Re: **Windhaven Estates Re-Plat Review**

Re: **Windhaven Estates Preliminary Civil Construction Plans - Review #1**  
Dear Ms. Hammonds,

Halff Associates, Inc. was requested by the City of Sanger to review the Preliminary Civil Construction Plans for the Windhaven Estates. This submittal was prepared by Homeyer Engineering, Inc and was received on November 4<sup>th</sup>, 2024.

PRELIMINARY CIVIL CONSTRUCTION PLANS  
for  
Windhaven Estates  
19.50 Acres  
City of Sanger  
Denton County, Texas  
October 2024

SEWER LINE B  
 PLAN AND  
 PROFILE

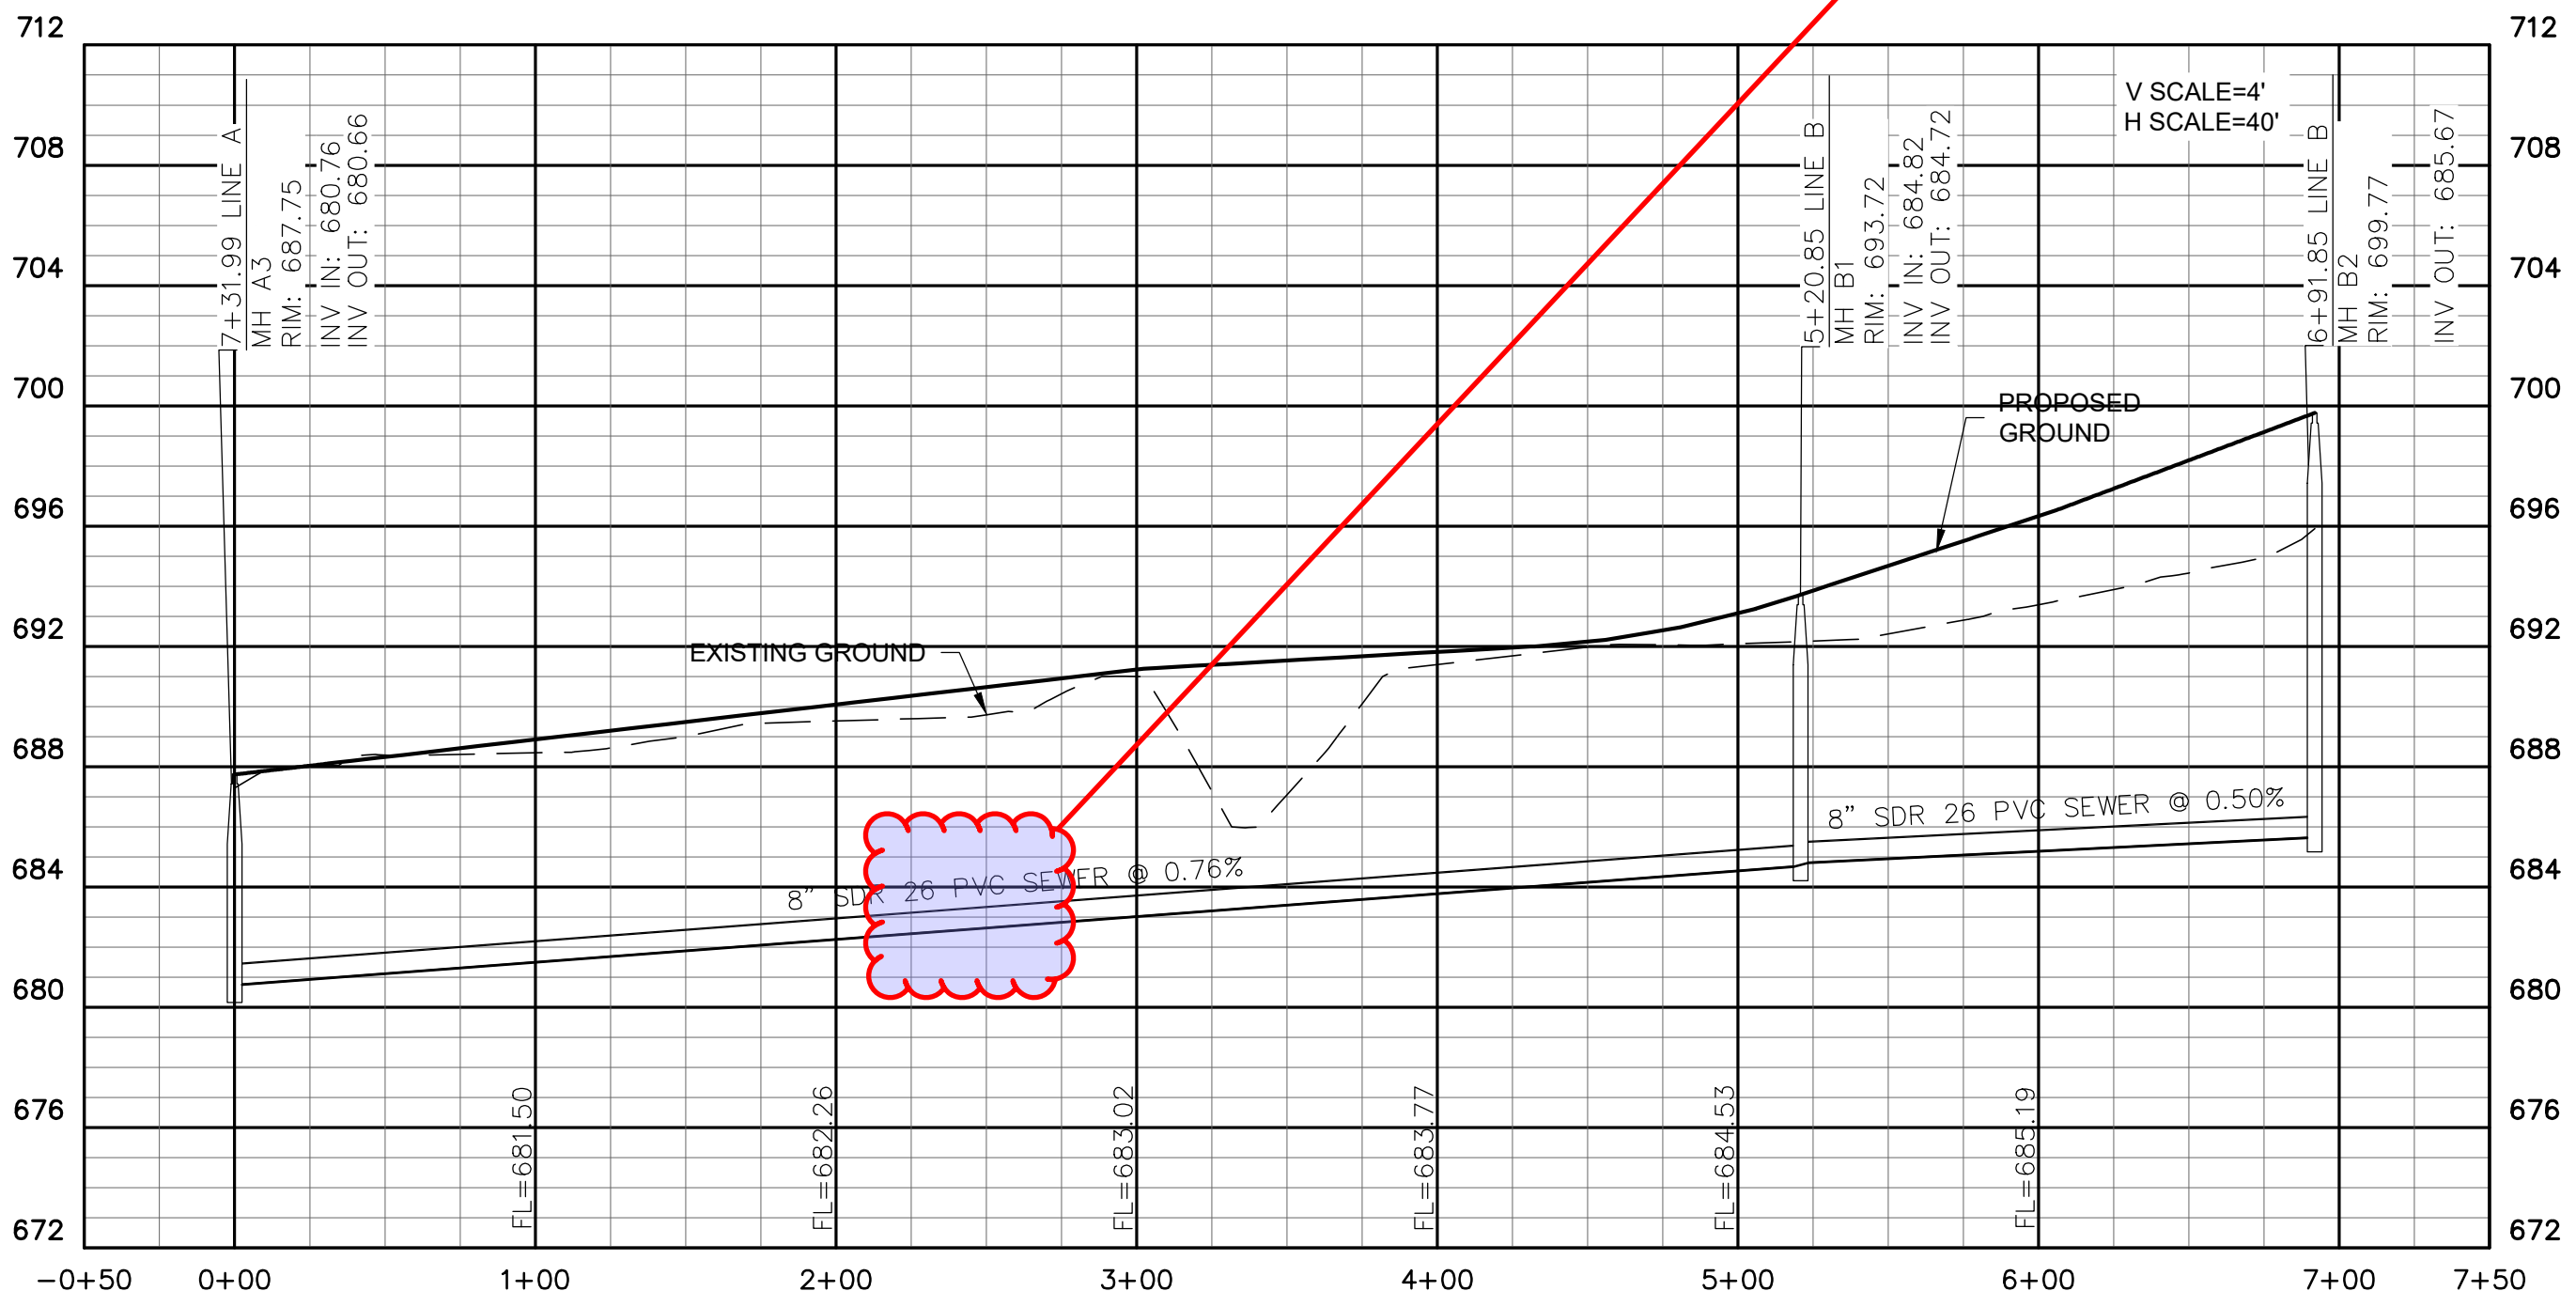
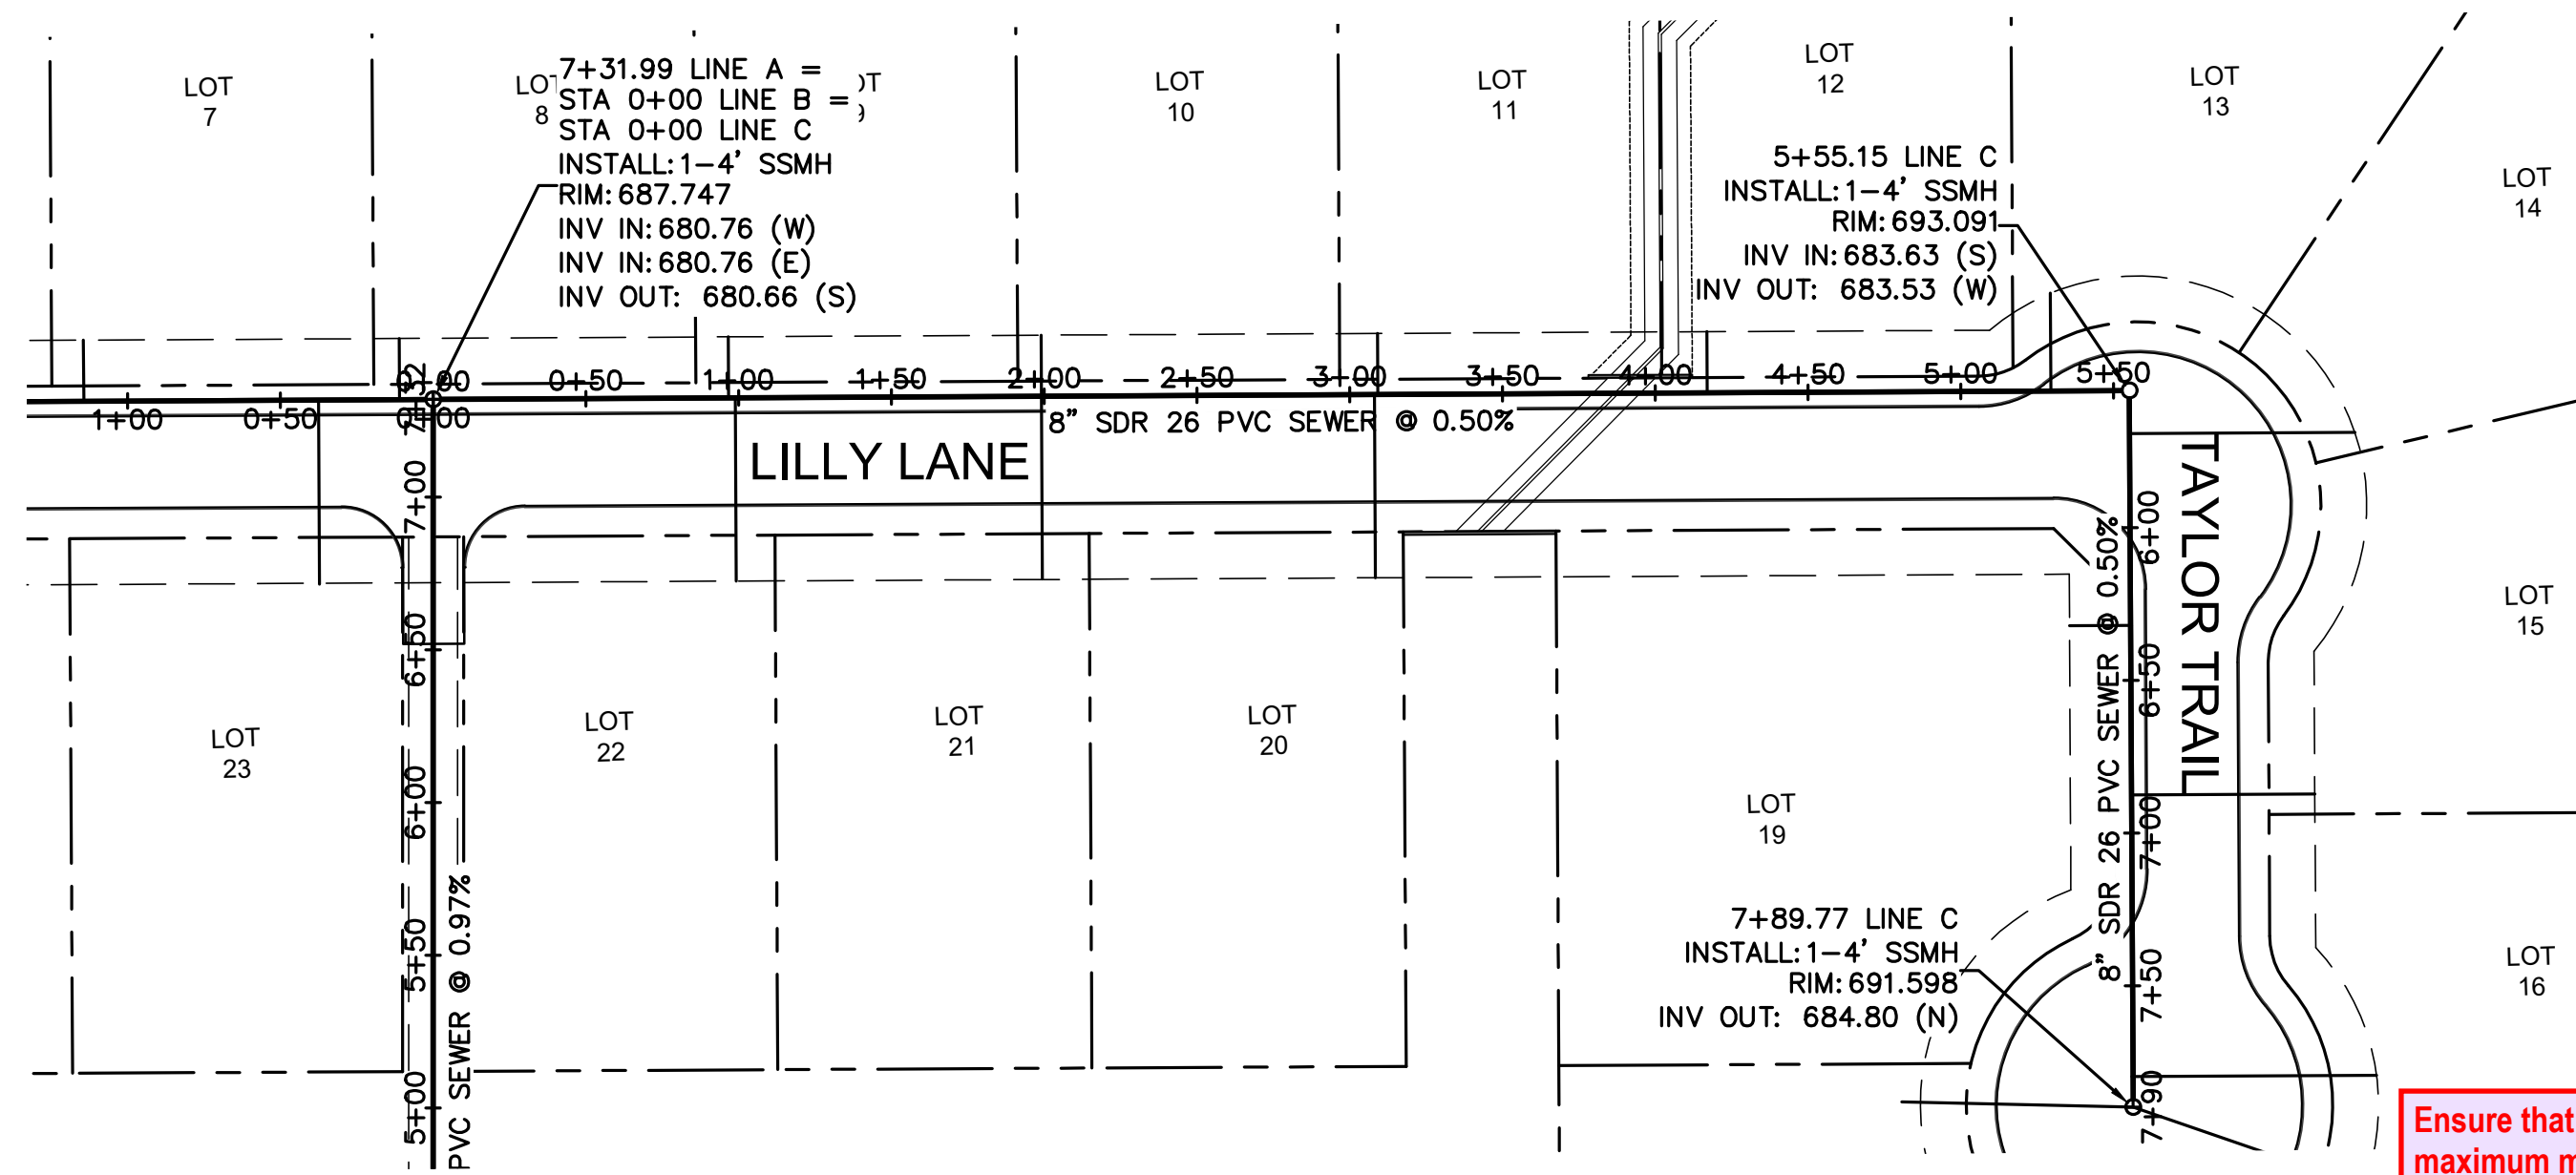
Ensure that the maximum manhole spacing is 500 ft in all cases

SEWER LINE C  
 PLAN AND  
 PROFILE

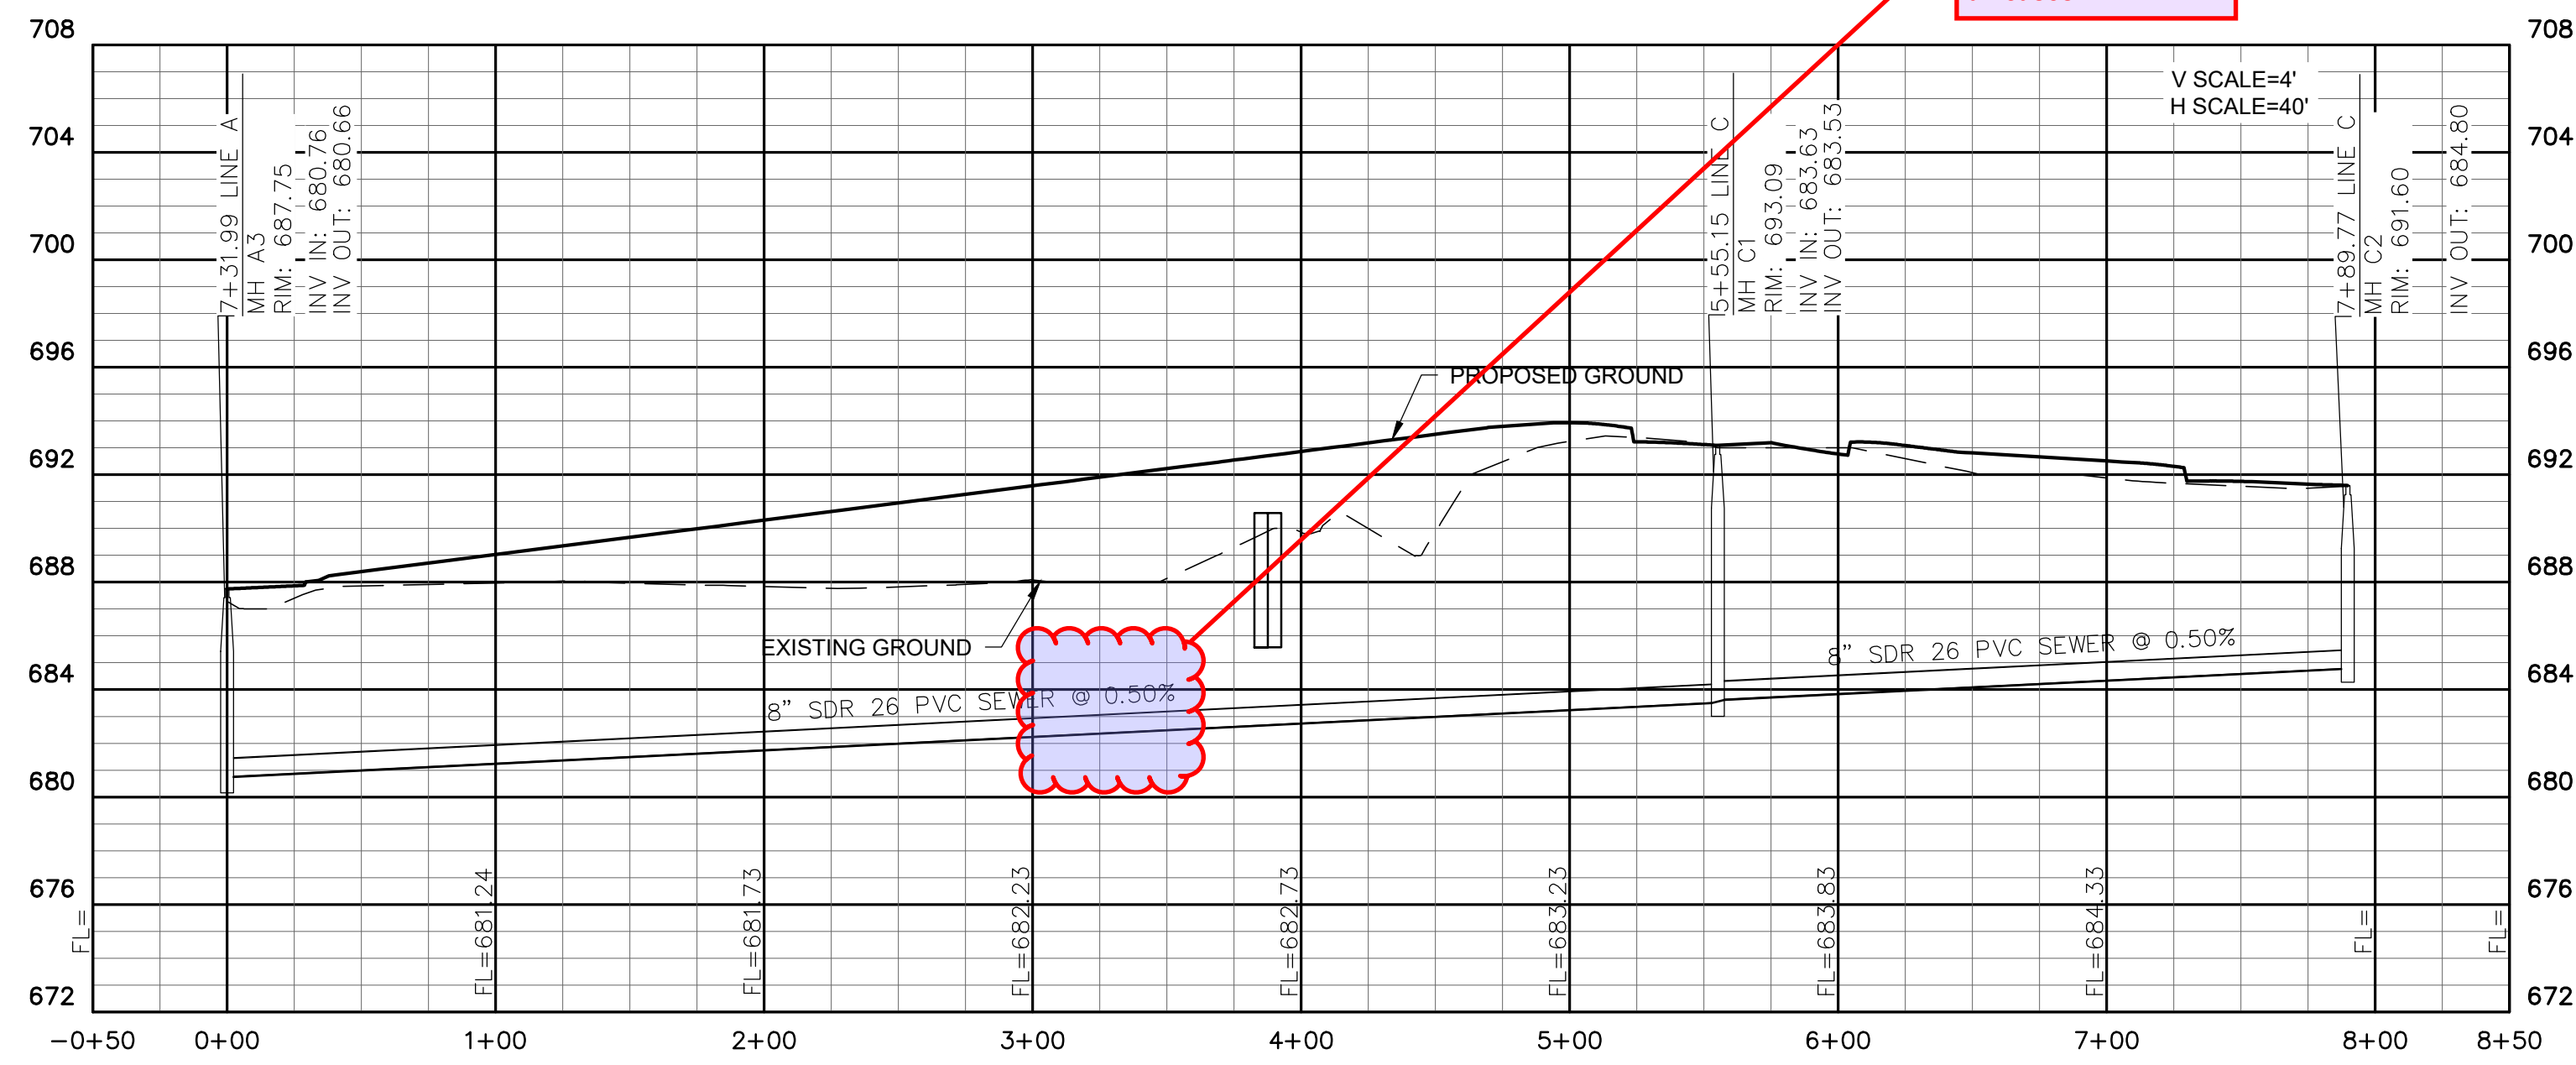
Ensure that the maximum manhole spacing is 500 ft in all cases
